AMENDMENT OF SOLICITATION/MODIFICATION OF CONTRACT		1. CONTRACT ID CODE		PAGE OF PAGES 1 14	
2. AMENDMENT/MODIFICATION NUMBER A0001		3. EFFECTIVE DATE 04/27/2026		4. REQUISITION/PURCHASE REQUISITION NUMBER PR15931550	
5. PROJECT NUMBER (if applicable)		6. ISSUED BY AMERICAN EMBASSY NEW DELHI 9000 NEW DELHI PL, ATTN: S/GSO WASHINGTON, DC 20521-9000 UNITED STATES		7. ADMINISTERED BY (if other than Item 6) AMERICAN EMBASSY NEW DELHI 9000 NEW DELHI PL, ATTN: S/GSO WASHINGTON, DC 20521-9000 UNITED STATES	
8. NAME AND ADDRESS OF CONTRACTOR (Number, street, county, State and ZIP Code)		(X) 9A. AMENDMENT OF SOLICITATION NUMBER 191N6526Q0039		9B. DATED (SEE ITEM 11) 04/16/2026	
		() 10A. MODIFICATION OF CONTRACT/ORDER NUMBER		10B. DATED (SEE ITEM 13)	
CODE		FACILITY CODE

Question & Answer Form Solicitation No. <u>191N6526Q0039</u> Title: <u>Provide Waterproofing services at Marine House Roof</u> Date: <u>27 April 2026</u>
Note: Contractors are advised to submit cut sheets of all the products which they are considering in their bid for evaluation.

**STATEMENT OF WORKS
FOR
ROOF WATERPROOFING
AT
MARINE HOUSE ROOF**

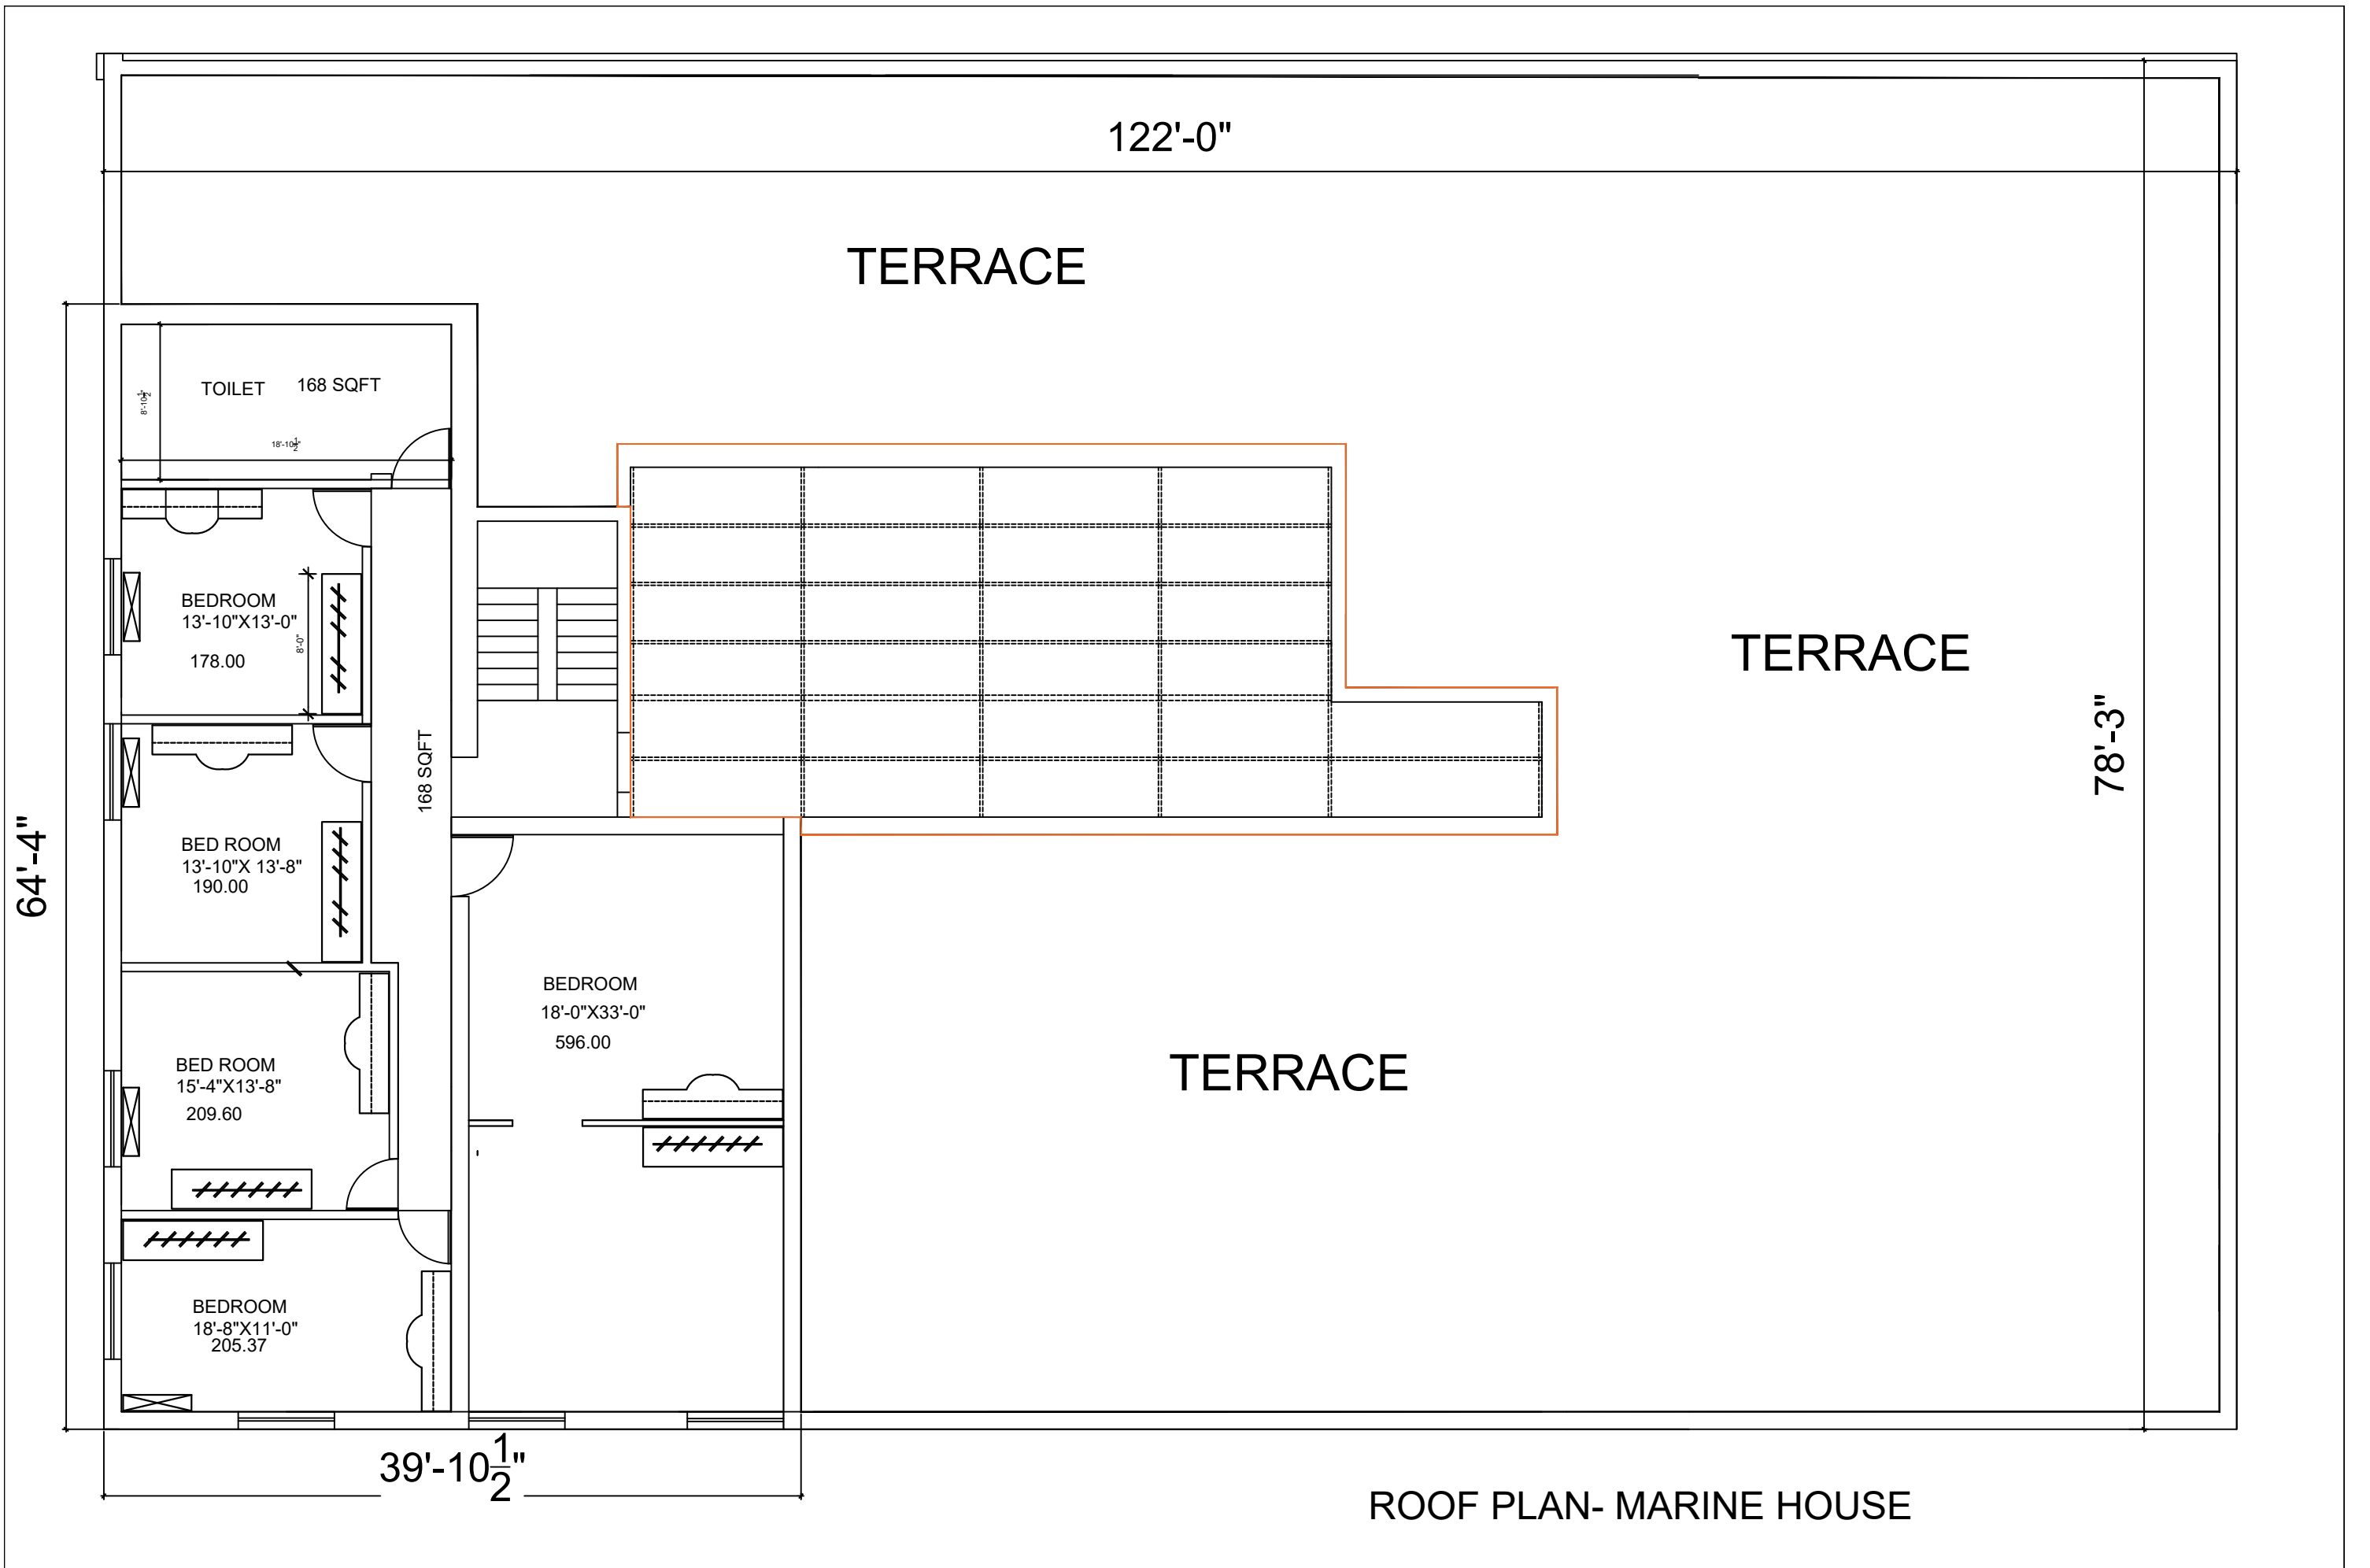
Answer-11: On Foam blocks.
Question-12: Serial # 3.5 - aluminium flashing - kindly specify the linear footage of the aluminium flashing to be provided, also kindly specify whether we have to provide "L" type aluminium flashing on the edges of overhang.

Answer-12: Please refer drawings for measurement and you must provide ‘L” shape and the one which gets inside the wall after chasing it. Both flashings are required as per the prevailing site conditions.
